SUBJECT : PLANNING PROPOSAL FOR KEY SITE GLADESVILLE

REPORT BY ARCHITECTUS GROUP PTY LTD

Figure 2 Preferred Design Scheme – View from South West
Source: Robertson & Marks Architects

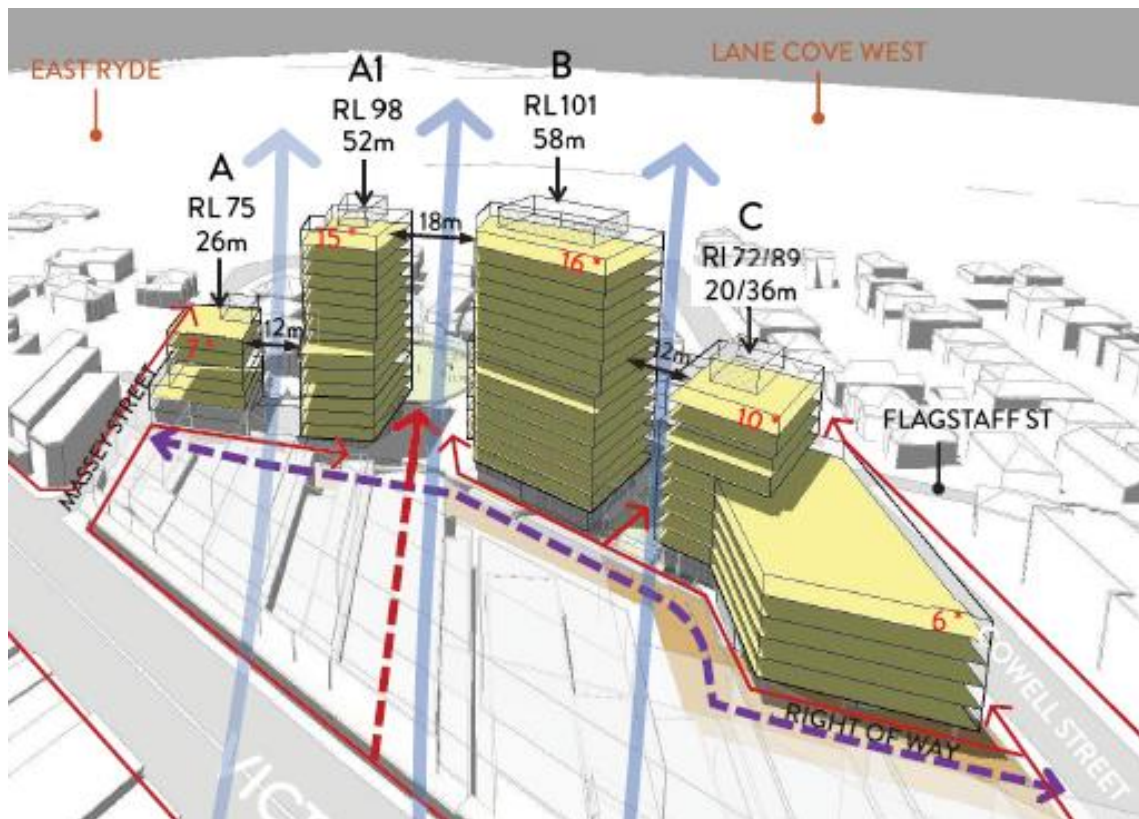
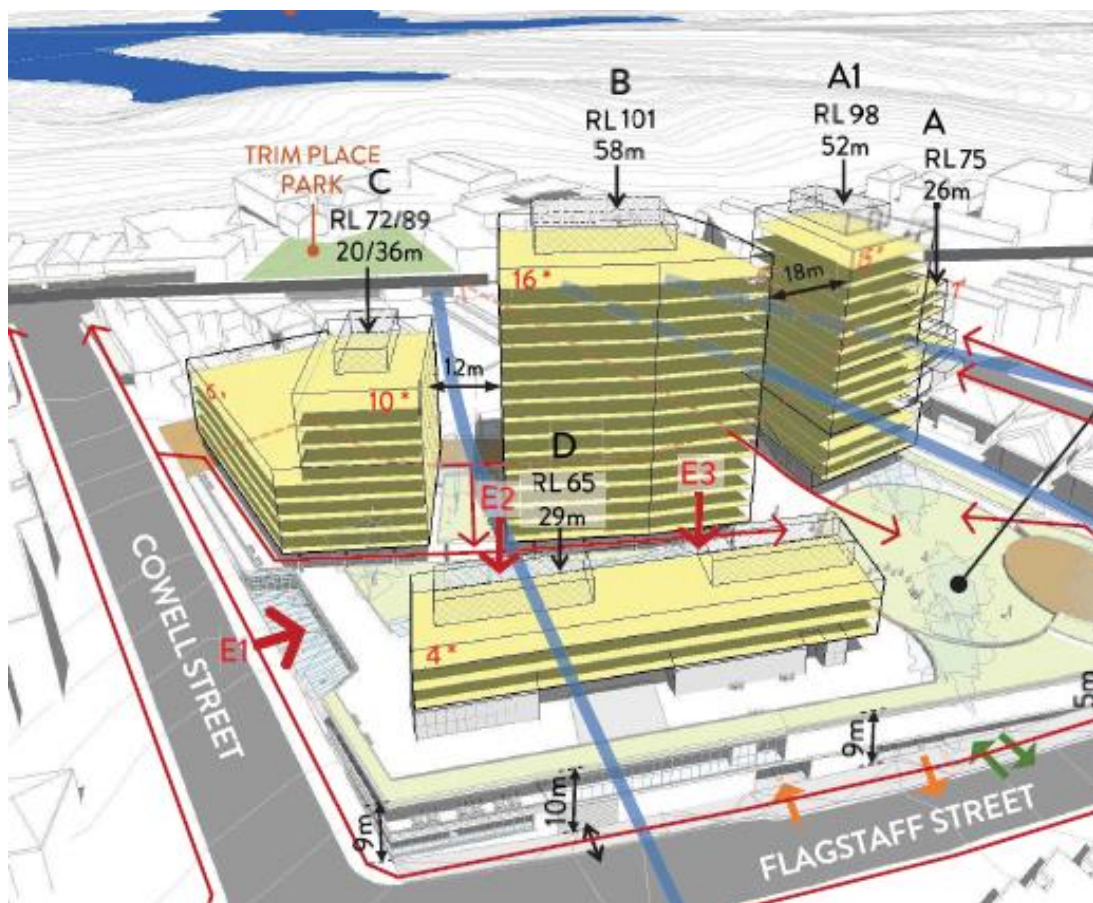
The figures below illustrate the 3D models provided as part of the Applicant’s Urban Design Report. It is noted that the relationship between the RL levels and the height in metres shown in the Urban Design Report are not clearly illustrated between the Planning Proposal and the Urban Design Report. The two expressions of height in some instances do not accurately align. In addition, it appears that inaccurate heights are illustrated on the plans. The height plan states that the height of the building closest to Cowell Street is at RL 89. With the ground level at this point shown as RL 42 to RL 45, the building is therefore 45-47 metres in height above existing ground level. This does not align with the height of 36 metres shown for the building in the Urban Design Report and Planning Proposal. Should the Applicant be given the opportunity to submit additional information, all documentation should consistently reflect height across the site to ensure there are no inconsistencies.

Figure 4 View from Flagstaff Street showing existing, compliant (requires verification) and proposed schemes

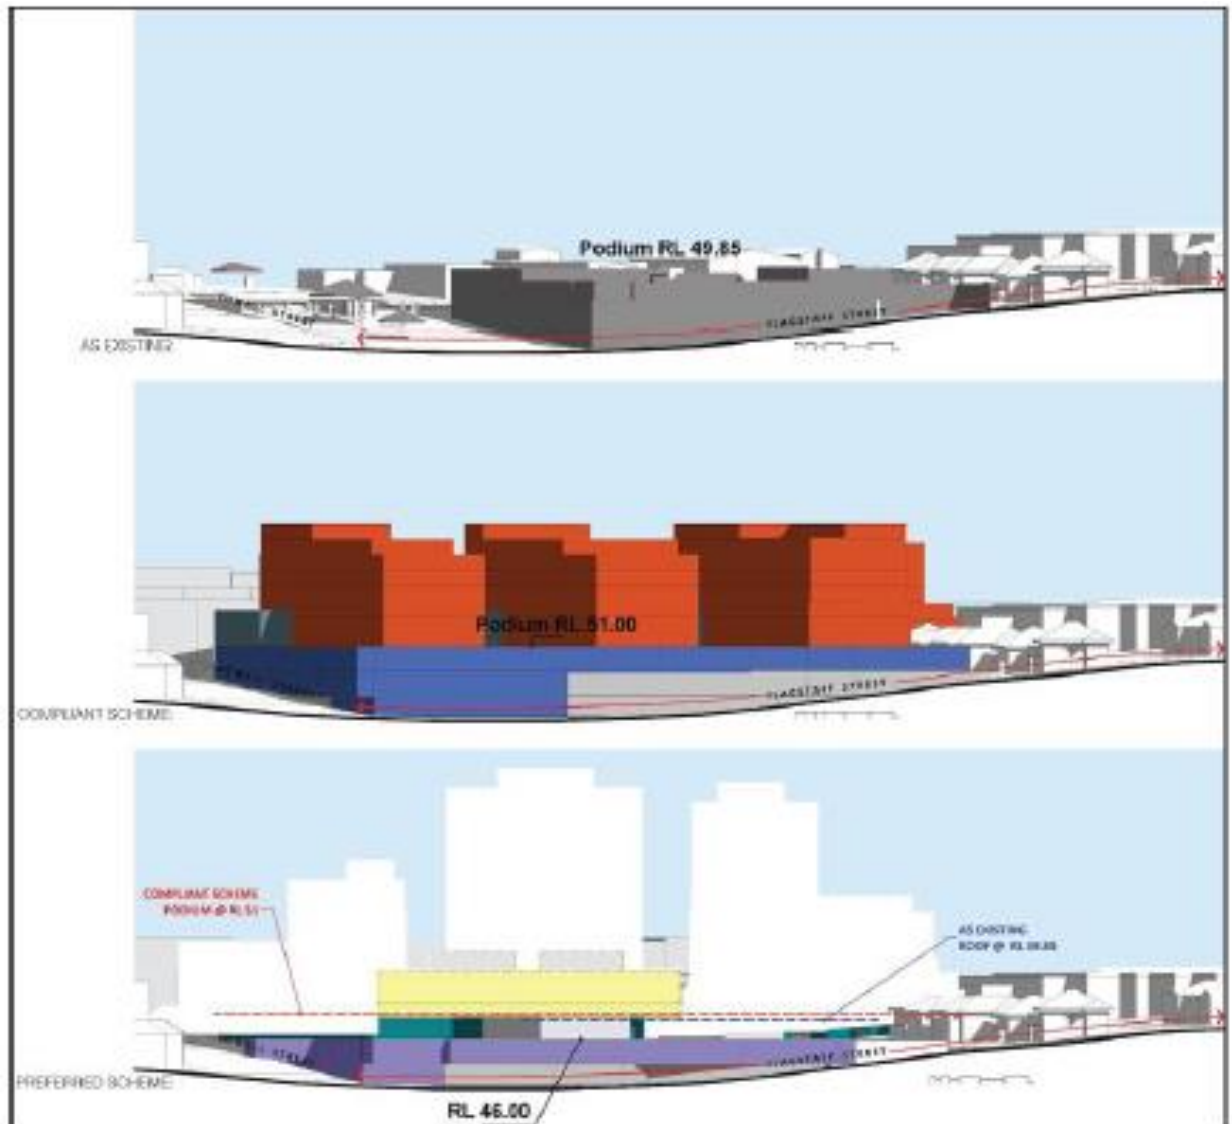
The Applicant has submitted elevations and assessed the visual impact of the proposal in comparison to a “compliant scheme”. These images are shown below. Concern is raised in relation to the depiction of the compliant scheme in the Applicant’s documentation. This

scheme appears to replicate the Withdrawn DA, which has not been assessed by the Applicant against current applicable planning controls, and therefore may not necessarily reflect a complying scheme. On this basis, the information submitted cannot be accurately assessed in terms of the impact of a likely development resultant of this Planning Proposal compared to a compliant scheme.

Should the Applicant be given the opportunity to provide additional information, the Visual Impact Assessment should be amended to provide a comparison between the likely resultant development outcome under the Planning Proposal and an accurate depiction of a complying scheme.
